Further Analysis of Transmitter dERL (Comment #189)

MediaTek

For IEEE 802.3ck

TX TDR and ERW with Sweeping R_d

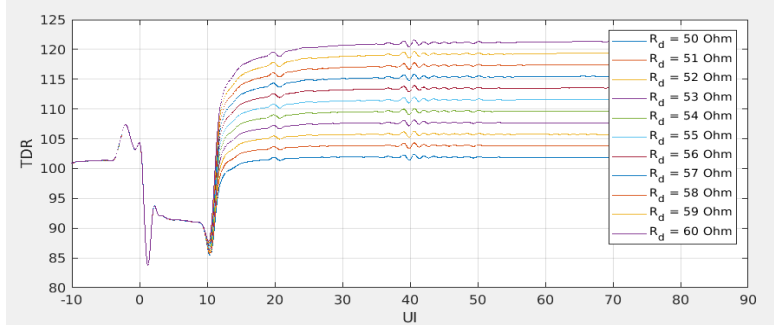
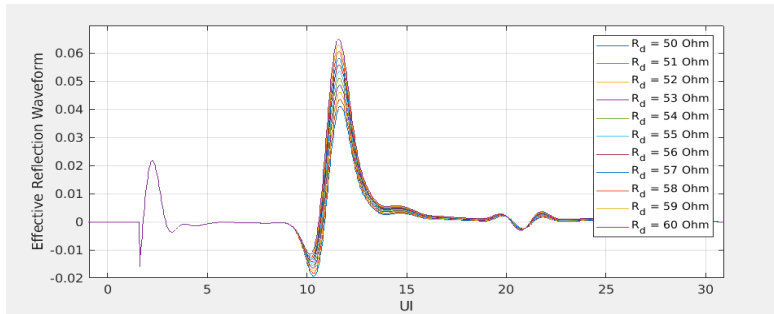
- In [dudek 3ck adhoc 01 042821](#), C_p (fF) was swept from 87 to 299, which may be too large a value to be representative
 - Impedance was as low as 65 Ohm, which is too low
 - Only one channel analyzed
- Based on that, we swept R_d instead & by 8 (baseline) + 1 KR channels

dCOM (dB) vs. dERL (dB) Analysis – Sweeping R_d

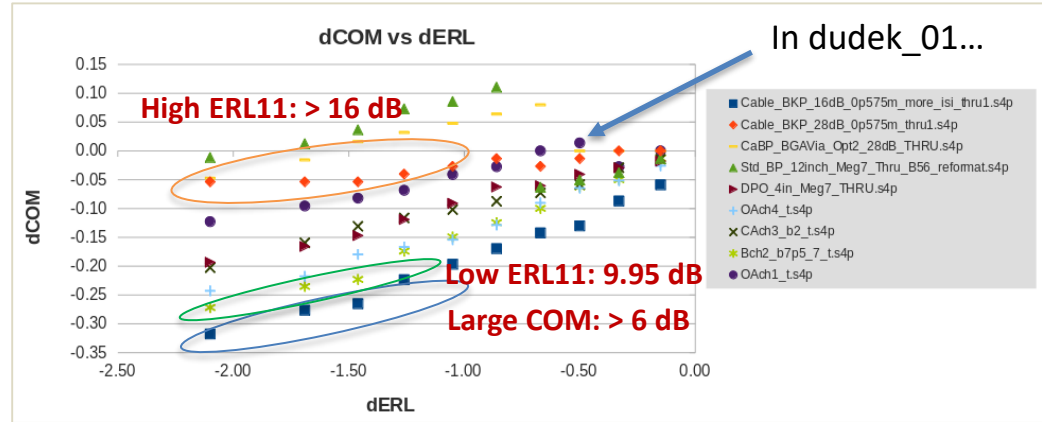
- dCOM = COM degradation due to lower ERL
 - Skip 'large COM'
- If dERL = -2.0 dB → dCOM ≥ -0.3 dB
- If dERL = -1.0 dB → dCOM ≥ -0.15 dB

- It shall be reasonable to take TX dERL as -3 dB

Figure 163A-1—Measurement method for transmitter reference steady-state voltage, pulse peak and ERL

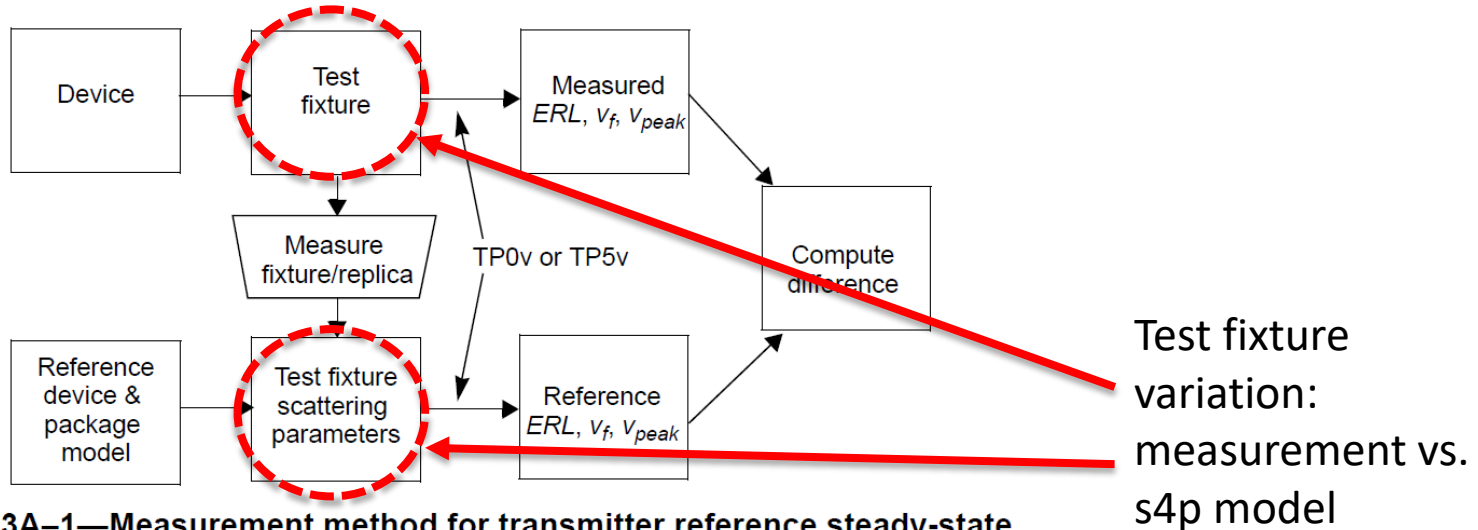
Take -1 dB for Test Fixture Variation
